TECHNICAL EVALUATION REPORT

CONTAINMENT LEAKAGE RATE TESTING

IOWA ELECTRIC LIGHT AND POWER COMPANY
DUANE ARNOLD ENERGY CENTER UNIT 1

NRC DOCKET NO. 50-331

Figure 1.

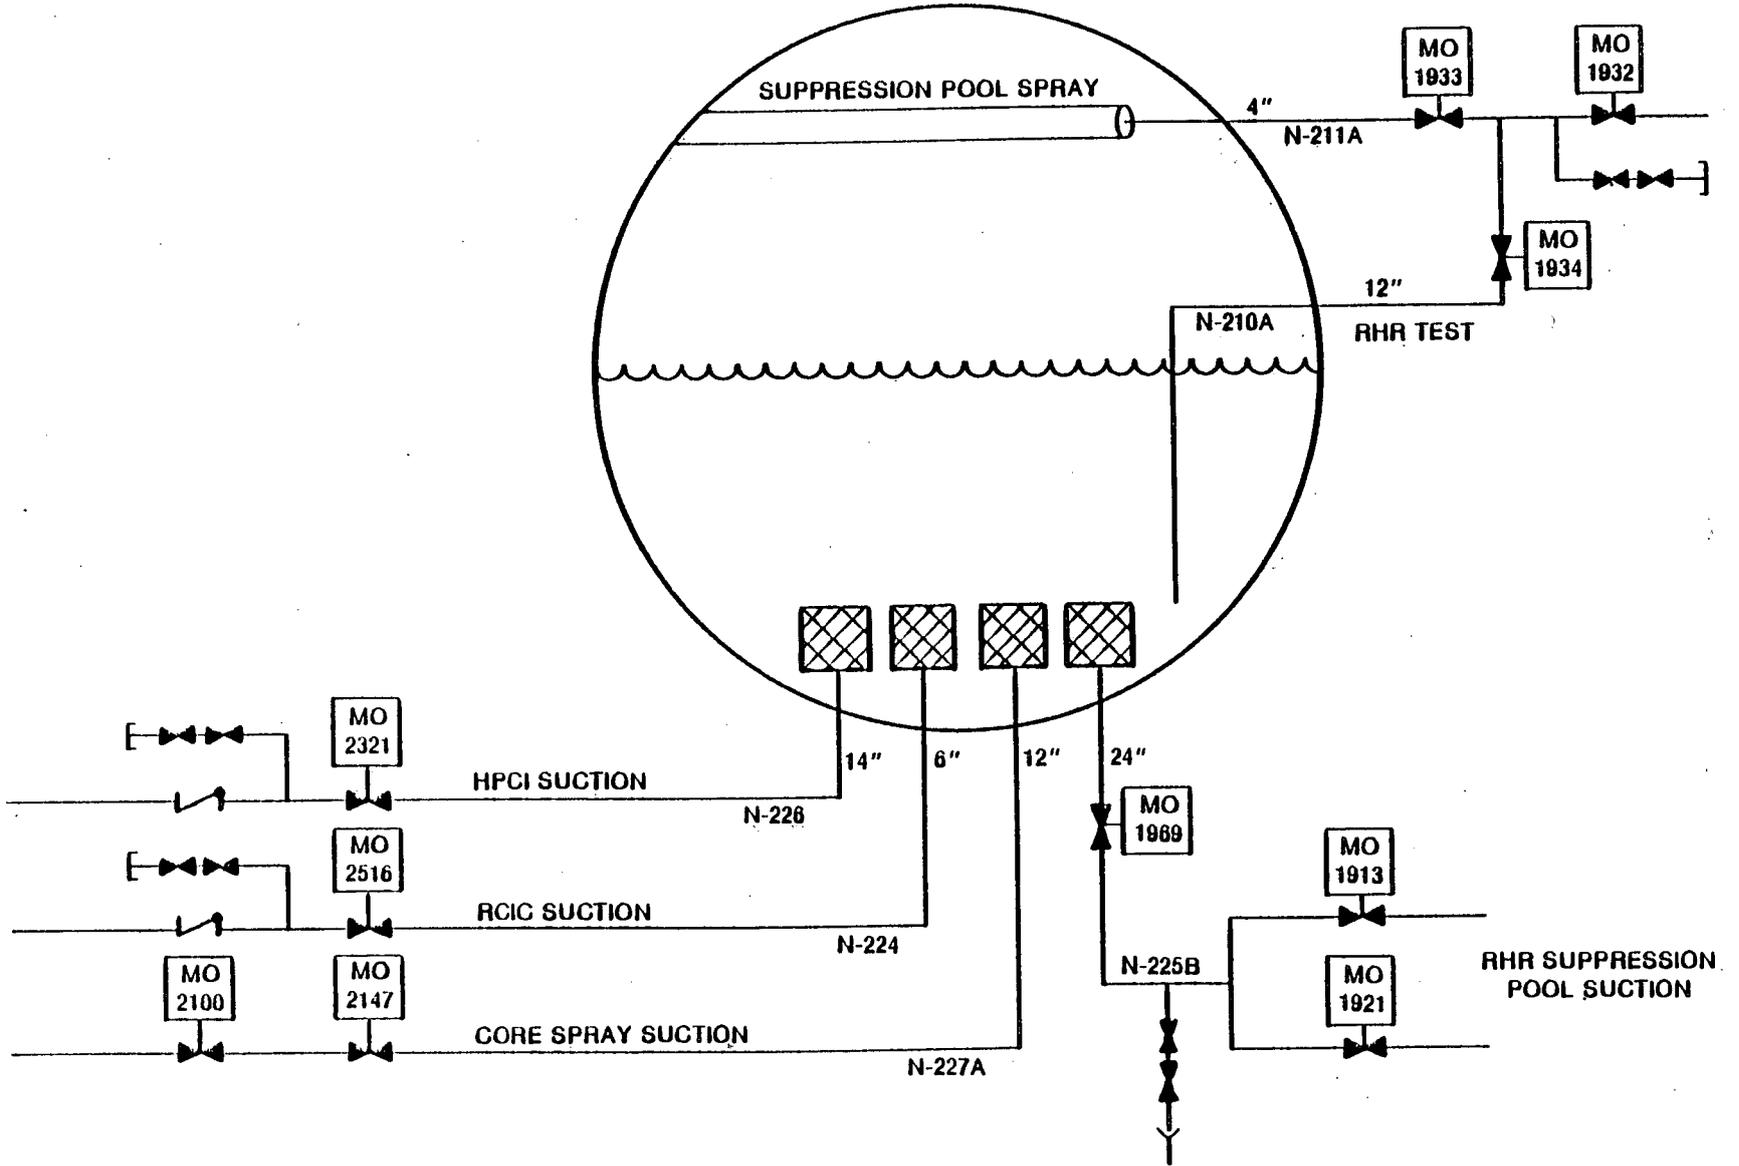
The piping configurations of concern are presented in Figures 1 and 2. Figure 1 shows the HPCI, RCIC, and core spray suction lines and one loop of the suction, suppression pool spray, and RHR test lines. Figure 2 shows one loop of LPCI injection, RV head spray, and containment spray. As can be seen in Figure 1, the HPCI, RCIC, core spray, and RHR suction lines are isolated from the containment atmosphere by the water level in the suppression pool. Since these lines are continuously water filled in a post-accident condition,

the isolation valves are not relied upon to prevent the escape of containment air to outside atmosphere; therefore, Type C testing is not required by Appendix J. Similarly, because the RHR test line terminates below the level of the pool, its isolation valve is also isolated from containment atmosphere, and Type C testing of this line is not required.

Figure 2.

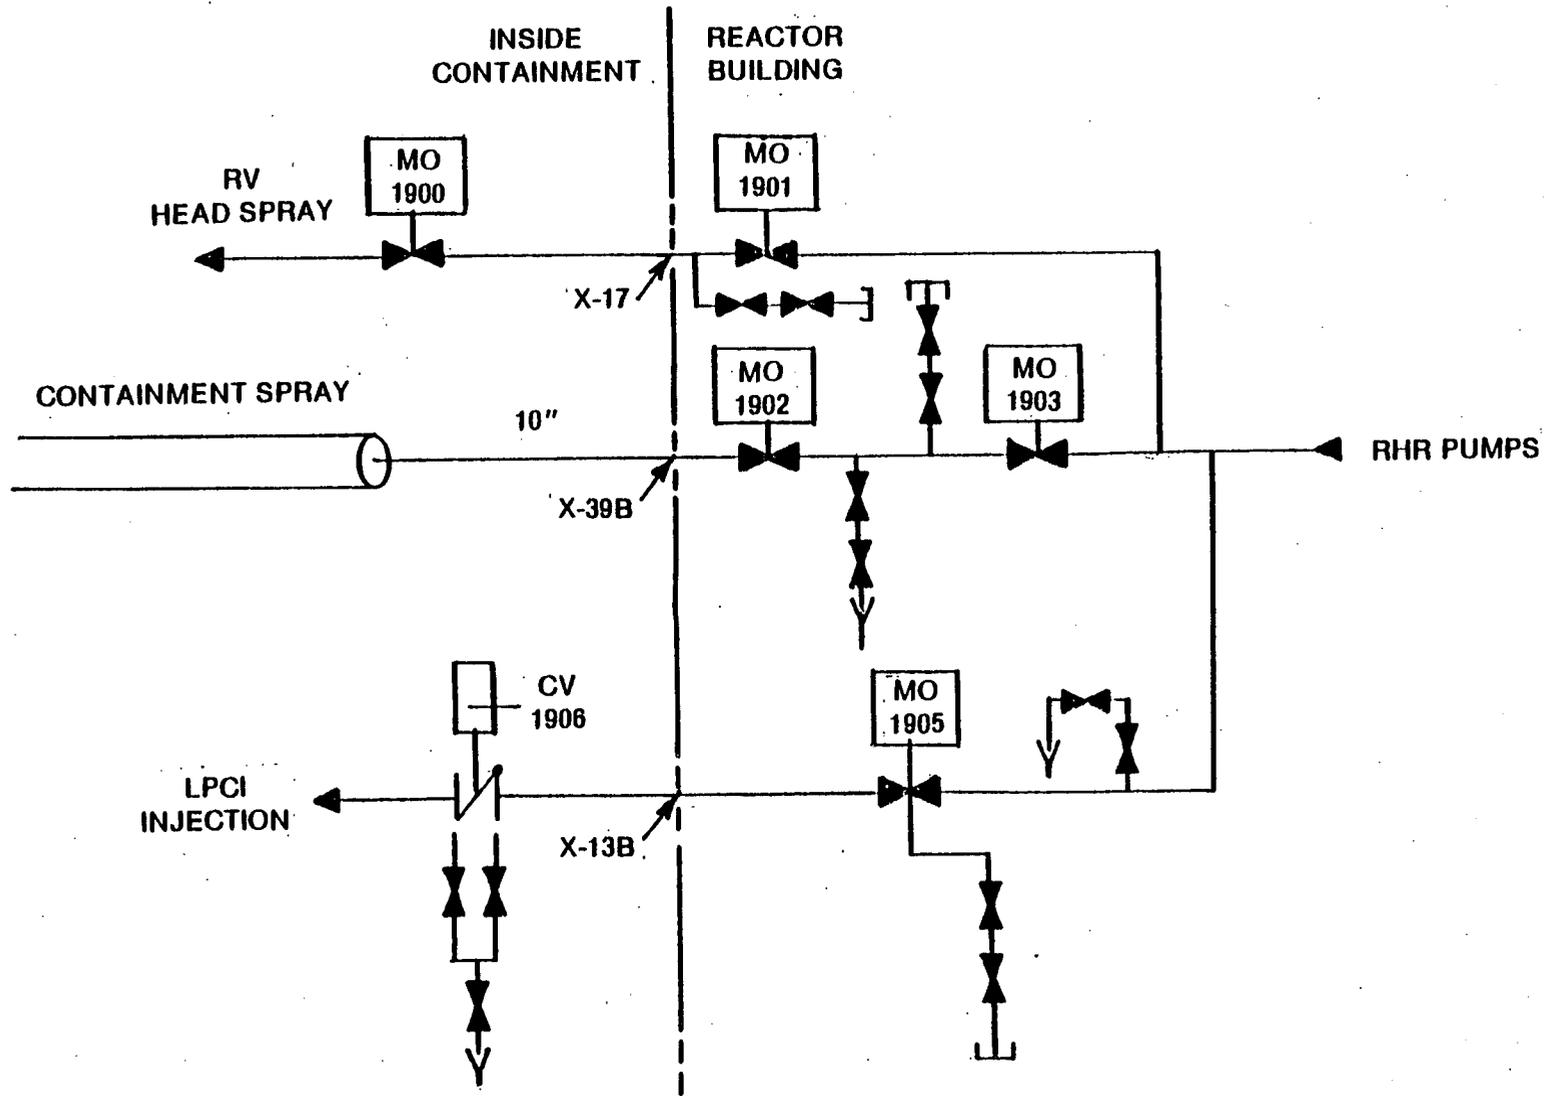
The LPCI injection line will be normally open and filled with water at a pressure greater than containment accident pressure as soon as safety injection is initiated. Furthermore, should valve MO-1905 (Figure 2) fail to open, the valve will be water sealed by RHR water at pump head pressure, and no single active failure can cause a loss of this pressure. Since MO-1905 is a gate valve, the water pressure will unseat the upstream valve disc and pressurize the valve packing and body-to-bonnet seal area with water. Consequently, there is no path for containment air leakage to the atmosphere through this line, even in the case of air leakage past the seat of check valve CV-1906. Therefore, this line is not a potential source of containment atmosphere leakage and the isolation valves are not required to be Type C tested in accordance with Appendix J.

Unlike the LPCI injection line the remaining three lines (suppression pool spray, containment spray, and RV head spray) are not automatically initiated by safety injection. Flow in these lines is left for manual initiation, if necessary, once sufficient reactor vessel level has been reestablished. Depending upon the severity of the accident, flow in these lines may not be established (particularly containment spray and suppression pool spray). Furthermore, at the start of an accident, there is no guarantee that there is any water in the line between the inboard and outboard isolation valves. In the case of these lines, therefore, there is a potential for containment air to escape to the outside atmosphere through the valve packing or body-to-bonnet seal area of the inboard isolation valve, even though the outboard valve is water sealed, as described in the case of valve MO-1905 of the LPCI injection line.

In the case of the reactor vessel head spray line, the inboard isolation valve is located inside containment (e.g., valve MO-1900). Leakage through the valve packing or body-to-bonnet seal is not a concern since any leakage is

merely internal to the containment and does not escape to the outside atmosphere. Consequently, the isolation valves of this line are not relied upon to perform a containment isolation function and do not require Type C testing.

For both the containment spray line and the suppression pool spray lines, however, the inboard isolation valves are located outside containment (e.g., valves MO-1902, MO-1933, MO-1934). If any of these valves leak through the packing or body-to-bonnet seals, the leakage of containment air reaches the outside atmosphere. Consequently, Appendix J requires that these valves be Type C tested. However, since the packing and body-to-bonnet seals are the only potential sources of leakage, the testing may be limited to these particular areas. Valve MO-1902 in the containment spray line is also a gate valve. Testing this valve by pressurizing between valves MO-1902 and MO-1903 achieves the intent of Appendix J because this test will unseat the upstream disc of valve MO-1902 and will pressurize the area of concern. Valves MO-1933 and MO-1934, however, are globe valves. FRC does not have sufficient information to determine whether the packing area is isolated from the containment side of the line when the valve is shut. However, assuming this is the case, these valves may also be tested by pressurizing between valves MO-1932, MO-1933, and MO-1934 since the area of concern will be subjected to the test pressure. If this is not the case, valve MO-1933 must be tested in the direction of accident pressure (note: by pressurizing between the three valves, MO-1934 is tested in the direction of accident pressure since its function in this case is to isolate the suppression pool spray line rather than the RHR test line).

In summary, Type C testing is not required and no exemption is necessary for the following penetrations because Appendix J does not require testing: N-210A & B, N-224, N-225A & B, N-226, N-227A & B, and X-17. For penetration X-39A & B, the inboard isolation valves should be tested in the direction of accident pressure or by pressurizing between the inboard and outboard isolation valves in order to test the valve packing and body-to-bonnet seals of the inboard valves. For penetration N-211A & B, the inboard isolation valves should be tested in the direction of accident pressure or by pressurizing

between the inboard and outboard valves provided that this testing will expose the packing and body-to-bonnet seal areas of the inboard valves to the test pressure.
